FORD 5R110W Torqshift NEW REAR PLANETARY AND INTERNAL RING GEAR

05-04

Figure 1

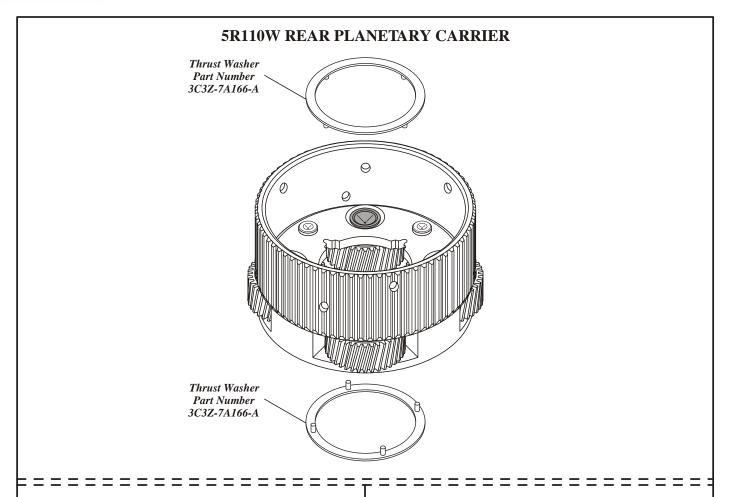
CHANGE: The rear planetary carrier assembly and rear ring gear hub have been changed for the 2005 production year because of pinion shaft movement in the carrier. Exploded view of all

low/reverse clutch parts is provided for you in Figure 1.

Figure 2

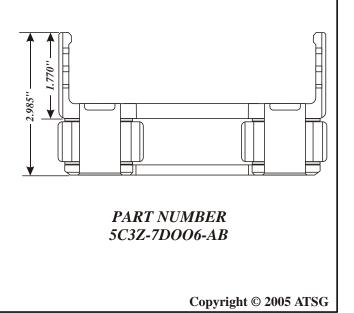
- (1) REAR PLANETARY CARRIER ASSEMBLY New carrier has a staking process change for the pinion pins to prevent them from "walking" out of the carrier assembly. There have also been some dimensional changes which helps us for identification. The overall height of the carrier has been reduced by .125" (1/8"), as shown in Figure 2. The splines for the low/reverse frictions have also been shortened by .125" (1/8"), as shown in Figure 2.
- (2) REAR RING GEAR HUB New design ring gear hub has the holes removed from the center, as shown in Figure 3.

The new design planetary carrier "Will" retro-fit back on all model years, and is required on any rebuild that has the previous design parts.

Note: "Do Not" reuse any previous design rear planetary carriers.
